Discussion on N_p for TX Output and RX Interference Tests

Mau-Lin Wu, Chung-Hsien Tsai, Chih-Long Dai, MediaTek

For IEEE 802.3ck

Linear fit pulse profile

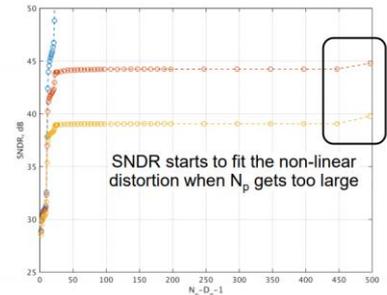
- For TX spec
 - 802.3bs D2.0 comment <#24> : TX SNDR in TX output spec uses $N_p = 200$ in 802.3bs D2.1
- Issues of small N_p value raised by Adam Healey in healey_3bs_02_0916.pdf
 - If N_p is too small, “test fixture reflection” was counted in TX SNDR (under-fitting) → not the intent of TX SNDR
 - If N_p is too large, SNDR starts to fit the non-linear distortion when N_p gets too large (over-fitting)
 - Proposed $N_p = 200$ in 802.3bs

SNDR starts to fit the non-linear distortion when N_p gets too large
